UNITED STATES PATENT AND TRADEMARK OFFICE

Office Action Summary	Application No. 10/624,219	Applicant(s) MELTON ET AL.	
	Examiner Larisa Z. Tsukerman	Art Unit 2833

DETAILED ACTION

Attachment 1

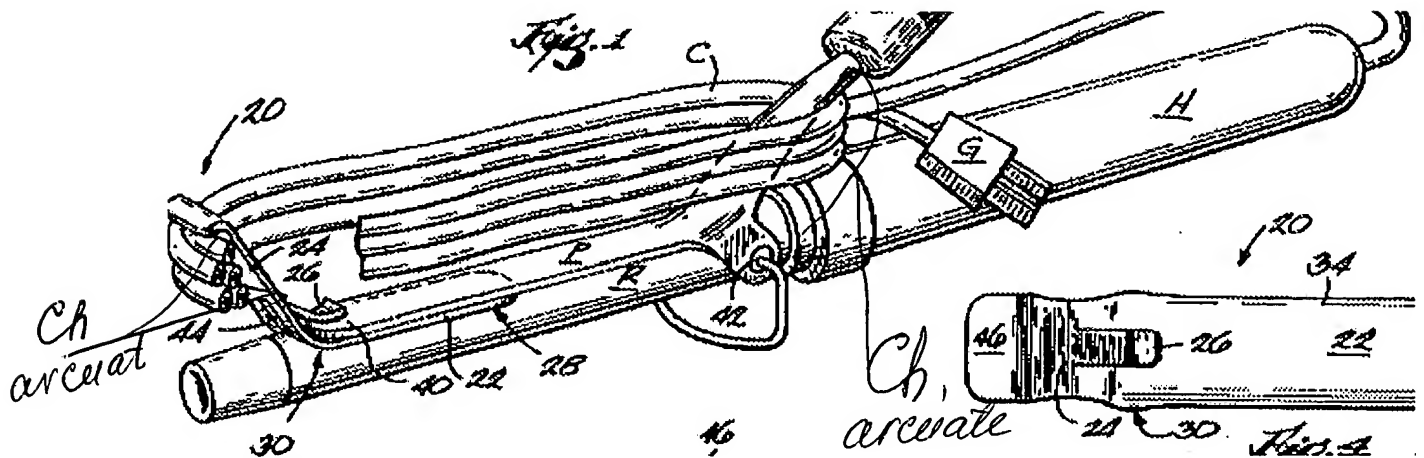
In regard to claim 1, St. Peter discloses a cord wrap 20 for use with a clipper (curling iron) configured for accommodating a power cord C, the cord wrap 20 comprising:

at least one retaining structure 22, 24, 26 configured for retaining the power cord C on the clipper (curling iron); and

a cord channel Ch (see Attachment 1) disposed on the at least one retaining structure 22, 24, 26 and configured for supporting at least one loop (not marked, see Fig.1) of the cord C.

In regard to claim 2, St. Peter discloses the one retaining structure 22, 24, 26 and the cord channel Ch maintain the power cord in a plane generally parallel with a longitudinal clipper (curling iron) axis (see Fig.1).

In regard to claim 4, as best understood, St. Peter discloses the cord channel Ch has a width sufficient to support the apex of the at least one loop of the power cord (see Fig.1).

- a cord channel Ch (see attachment 1) disposed on the retaining structure 24 configured for supporting at least one loop of the cord (see Fig. 1); and

- a support P, 28 disposed between the front en and the rear end of the retaining structure for connecting the rear end to the front end (see Fig.1).

In regard to claim 17, as best understood, St. Peter discloses the cord channel Ch is configured to receive and support at least one apex of the at least one cord loop (see Fig.1).

In regard to claim 18, St. Peter discloses the cord channel Ch is disposed on a front end (area 44) and a rear end (area above numeral 42) of the retaining structure 22, 24, 26, the cord channel Ch being defined by members being arcuate in profile (see Fig.1).
